<b>Planning and Zoning Commission</b>	<b>AGENDA</b>  # _____
	<b>STAFF REPORT</b>

**MEETING DATE:** February 5, 2015

**Request by United Engineering Group** for the following land use approval on approximately 104 acres located south of McCartney Rd acres, generally located south of where Palomino Parkway terminates at McCartney Rd (APN #s 505-03-004A, 505-03-0030, 505-03-006A, 505-03-007C):

**1. DSA-14-00163: Major Amendment to Marabella PAD. Said amendment includes the following changes:**

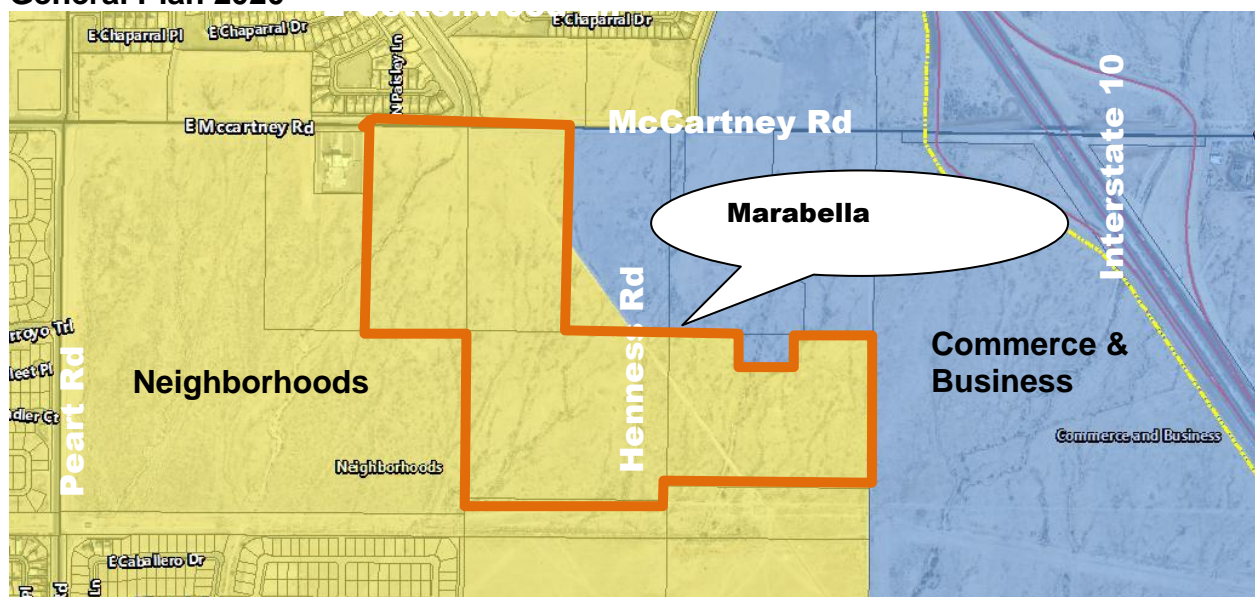
Marabella is a flat, currently undeveloped area. It is relatively undisturbed in its natural desert-state except for a 60 ft.-wide gas-line easement that traverses the site from a southeast to northwest direction. The only areas adjacent the site that have been developed is the McCartney Center neighborhood to the north, and the Casa Grande Fire Department to the west. The plan proposes working with the existing conditions by proposing an open-space spine and multi-use pathway identified as the “T-12 (Pipeline) Trail” within the Casa Grande Parks Master Plan alongside this pipeline, and aligning Henness to intersect at McCartney Rd where Palomino Parkway terminates. Historic drainage flows from a northeast to southwest direction across this site. The primary channel, which flows from the north through McCartney Center then exiting Marabella to the west, is shown to be an open space amenity.

Currently, the PAD provides an open space buffer between the single-family lots and McCartney Rd as well as between the lots and the western boundary of the PAD adjacent to the fire station. The proposed amendment does not show a buffer in these areas. A landscaped open space tract is recommended in these areas to help mitigate the potential off-site impacts. Buffering lots adjacent to major arterial roads by open space is a way to help mitigate impacts from road noise, lights, and pollution. The proposed amendment shows this type of buffer provided for lots adjacent to Hennessey Rd, another major arterial within the PAD, and similarly should be offered for those lots adjacent to McCartney Rd. The concern for lots adjacent to the Casa Grande Fire Department to the west is that when trucks are dispatched, sirens and lights can be a detriment to these future homeowners. Added open space between the fire station and this area would help bolster use-to-use compatibility. A condition of approval is that the plan be revised to provide a 15 ft. to 20 ft. open space buffer between lots and McCartney Rd and between lots abutting the fire station.

- 1. Revise the plan to provide a 15 ft. to 20 ft. open space buffer between lots and McCartney Rd and between lots abutting the fire station.**
- 2. The access points onto McCartney Rd from local streets east and west of Henness, be eliminated.**
- 3. The PAD amendment shall be revised to comply with the Residential PAD Guideline which requires that for every lot less than 7,000 sq. ft. an equal number of lots of at least 8,000 sq. ft. be provided.**

## Exhibit C – Street cross sections

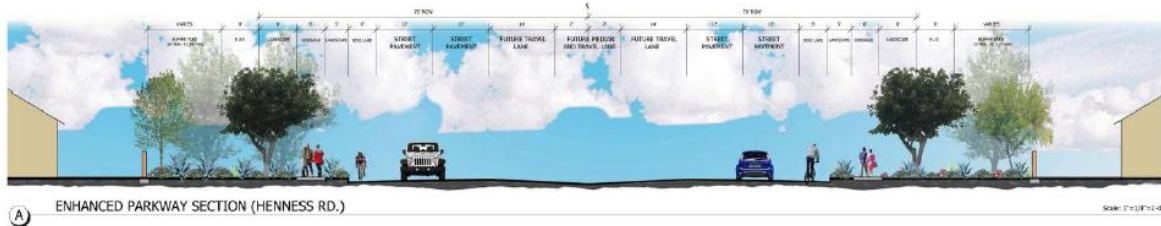
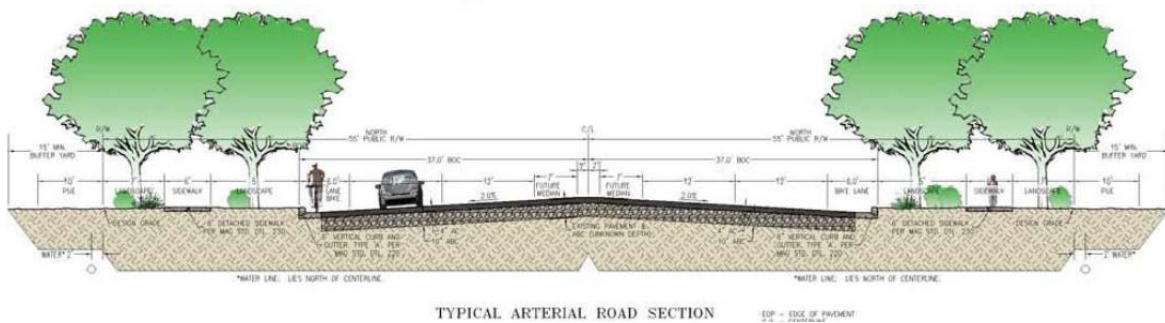
One of the significant changes to the Marabella PAD is the re-alignment of Henness Rd and the cross-sections provided for it (Exhibit C). The amendment proposes an “enhanced parkway” design with an abundance of landscaping along it. Sidewalks, bike lanes and vehicle travel lanes will initially be developed near the edges of the right of way, with future travel lanes and the median provided in the center at a point in the future. Both Henness Rd and McCartney are to be 140 ft. wide, major arterial roads.

## Exhibit 7 - Typical Local Street R.O.W. Section

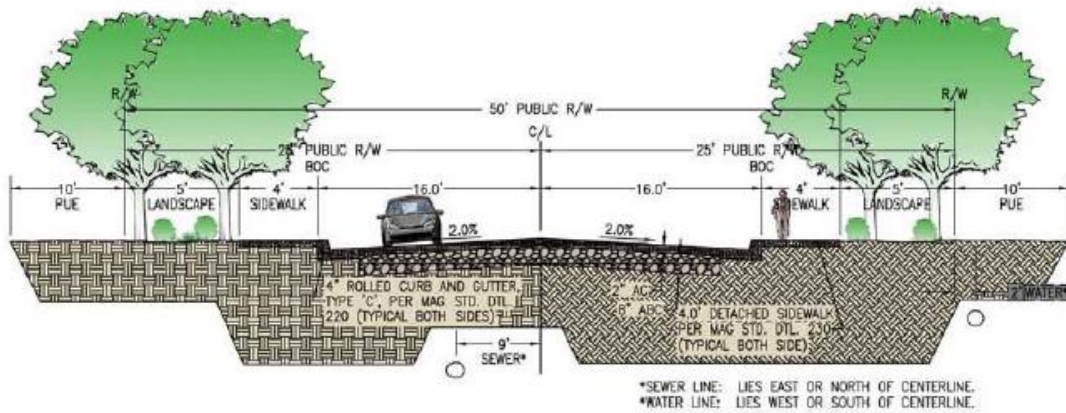
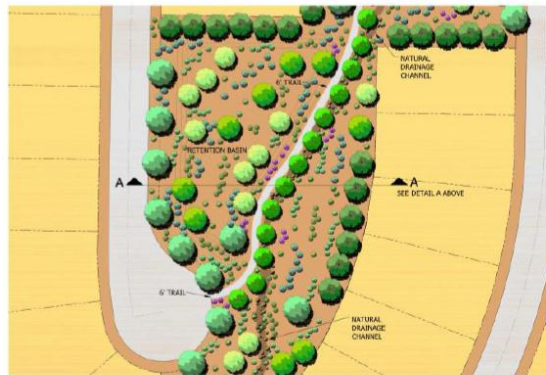
Cross sections of local streets have also been provided in the PAD.
